Certificate of Appropriateness & Alternative Design Variance
1131 Jenifer Street

April 3, 2023

SECOND FLOOR BATHROOM REMODEL
1131 JENIFER ST
MADISON, WI
CORDELIA FANTOVA, OWNER

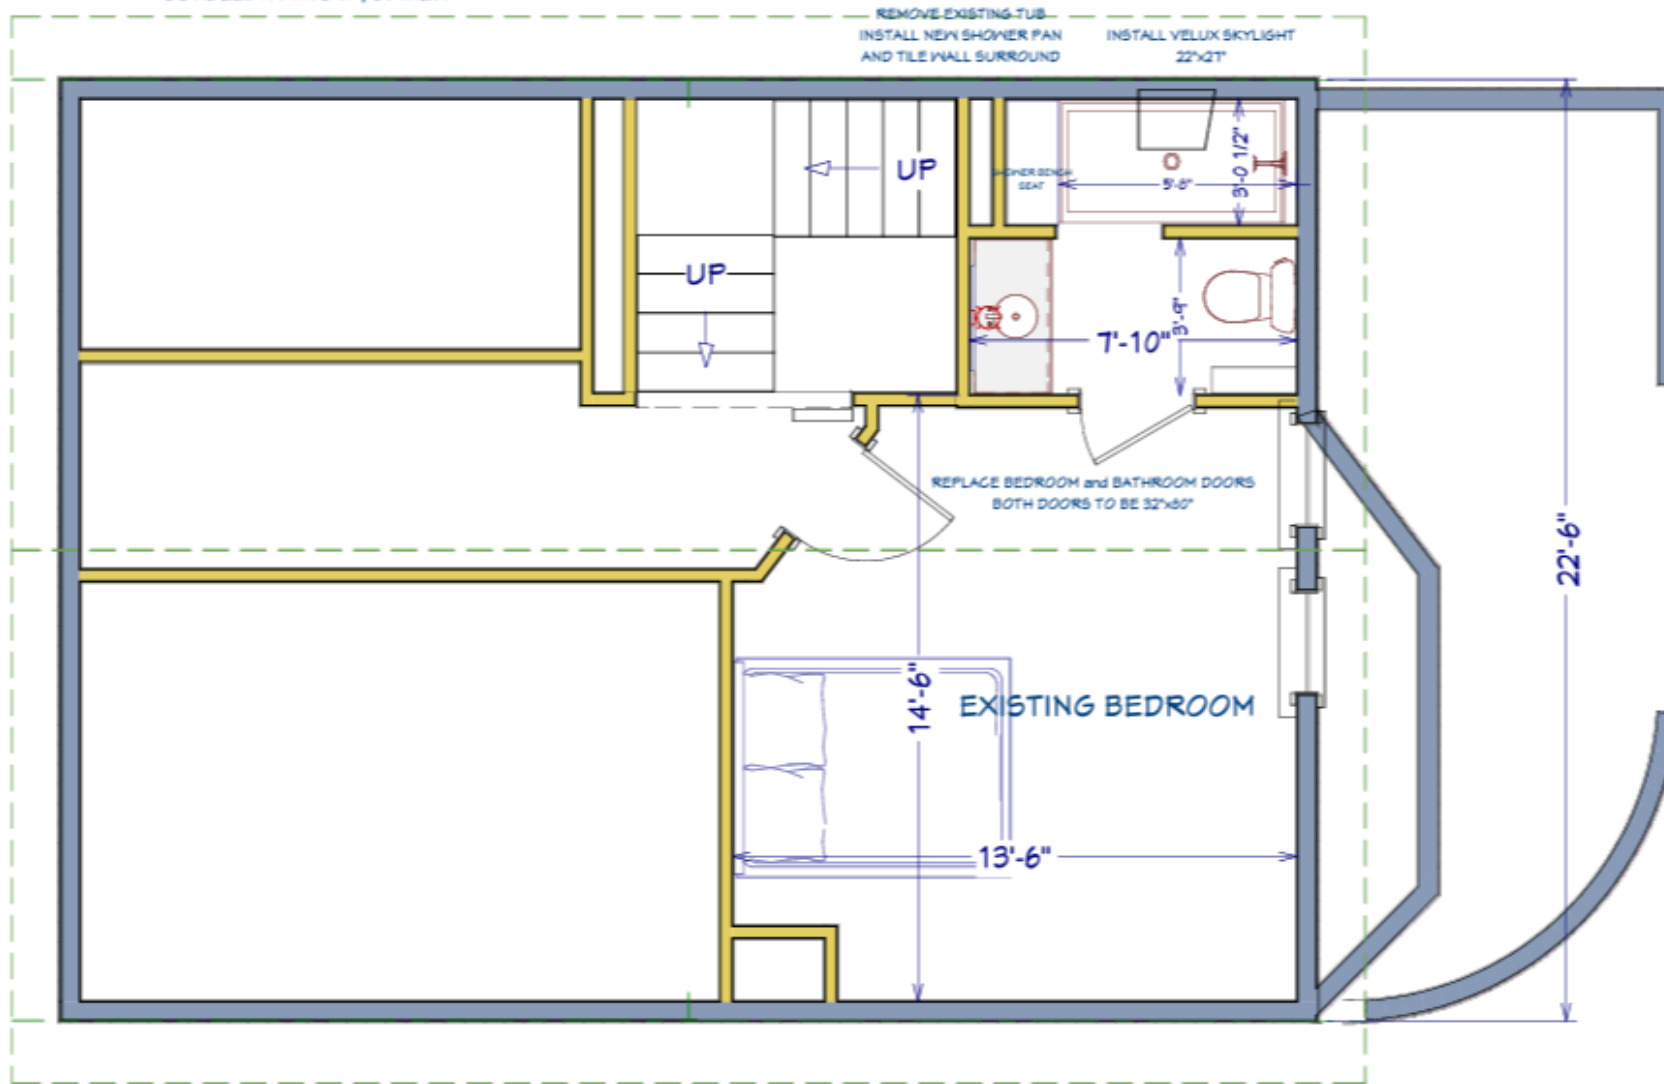
- Remove nonhistoric window on front façade
- Install operable skylight 8' from front edge of roof
- Standards require 12' from front edge of roof

1. Skylights visible from the developed public right-of-way shall be flat, parallel to the slope of the roof, and have the frame painted to match the roof material, and be located least twelve (12) feet back from the front edge of the roof.

Staff believes that the standards for granting a Certificate of Appropriateness are met and recommends the Landmarks Commission approve the project as proposed.
